Proposed Code Modifications

This document created by the Florida Department of Business and Professional Regulation -
850-487-1824

TAC: Swimming Pool

Total Mods for **Swimming Pool** in **Pending Review**: 59

ITEM #	MATERIAL: PVC WHITE ONLY	SCALE: 1" = 1'-0"	LAWSON AQUATICS
MLD-SG-1818-WT(WHITE)	QTY: PVC WHITE / BLACK	REVISED: DATE: 08/11/2017 BY: [Signature]	CREATED BY: DATE: 08/11/2017
MLD-SG-1818-BK(BLACK)	REVISED: DATE: 08/11/2017 BY: [Signature]	DATE: 08/11/2017	18" X 18" MAIN DRAIN SUMP AND GRATE

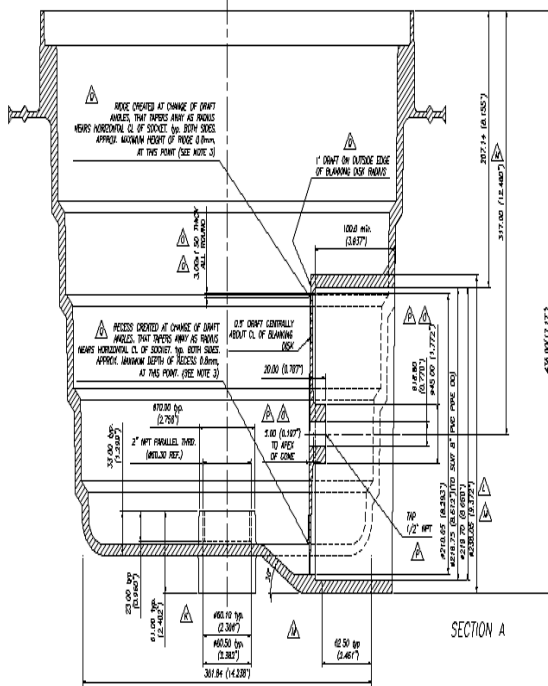
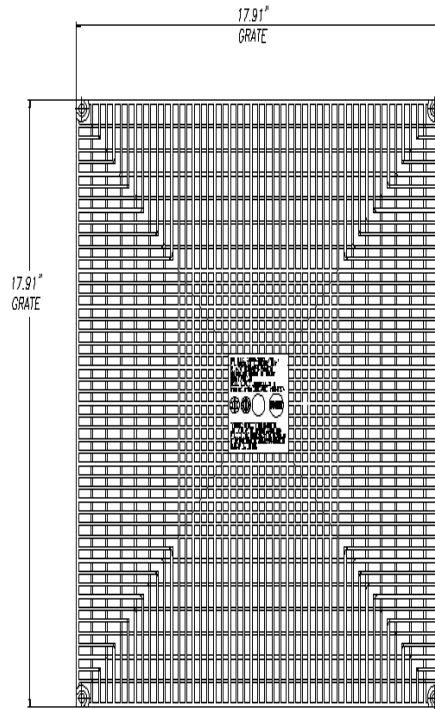
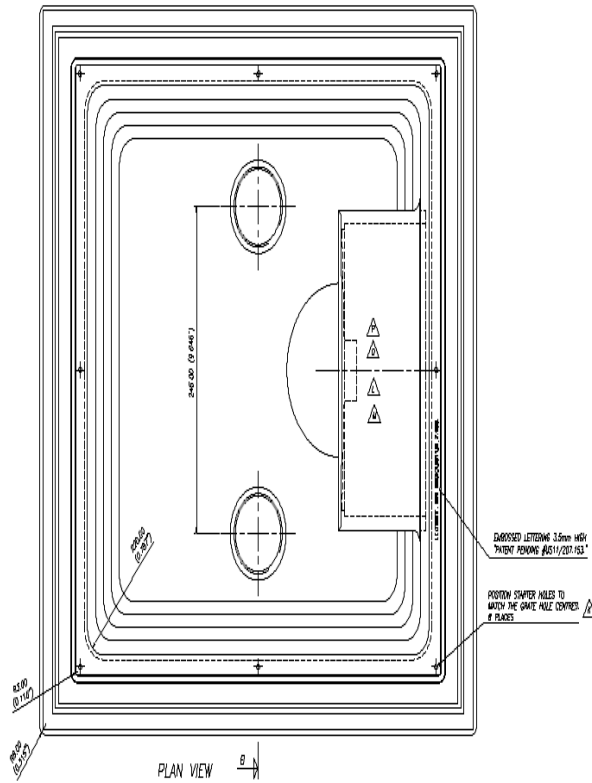
Here the building code conflicts with national standards and current practice from leading drain grate manufacturers. Note the attached drawing. This popular drain grate is stamped with a maximum, national code compliant flow rate of 816 gallons per minute, but only accepts an 8" pipe. In Florida currently, a pool builder can only route about 500 gallons per minute through this drain, legally, because any faster would violate the 3 ft/s rule for pipes. Further, flows above about 570 gallons per minute would violate the 1.5 ft/s rule.

SW7258-G1	Proponent	Michael Weinbaum	Submitted	1/8/2019	Attachments	No
	Comment:	<p>What I wrote under &quot;rationale&quot; has a math error.</p> <p>The 1.5 ft/s rule would actually limit the grate shown in the attached drawing to 855 gallons per minute, not 570 like I wrote. But the ANSI/APSP-16 rating is less, 816 gpm is stamped on the grate. As written, Florida code requires the engineer and the building department official to check three things: the ANSI/APSP-16 flow rate, and the open area, and the pipe connection size, and then do math to figure out which of the three works out to less flow. This seems like unnecessary work in light of how much testing the manufacturers perform to obtain their ANSI/APSP-16 flow rate.</p>

SW7258-G2	Proponent	Kari Hebrank	Submitted	2/13/2019	Attachments	No
	Comment:	The Florida Swimming Pool Association is OPPOSED to this code modification because it exceeds all other design standards and there are safety concerns with maximum flow velocity.

SW7258-G3	Proponent	robert vincent	Submitted	2/18/2019	Attachments	No
	Comment:	<p>This Mod will weaken the code for anti-entrapment and would likely violate the federal law for pool suction outlet anti-entrapment which references the national suction outlet standard in the FBC, as does also the Florida Statute at s.514.0315(1). There is no need to eliminate the 1.5 ft/s flow through main drains as all professional designers are familiar with the FBC and the gravity drainage criteria. When a lab using the nationally referenced standard tests a drain grate at 1.4 ft/s or less, this is reflected in published spec sheets of the manufacturer and compiled in a code compliant drain list by the Dept. of Health on the public swimming pool webpage: http://www.floridahealth.gov/environmental-health/swimming-pools/index.html</p> <p>Florida's gravity flow systems to collector tanks, combined with the current maximum flow velocities through main drain gates, suction, gravity and pressure lines has served the citizens of this State well – without a single documented suction entrapment. The issue of direct suction vacuum ports is recognized and a proposed code modification has been submitted to address this issue.</p>
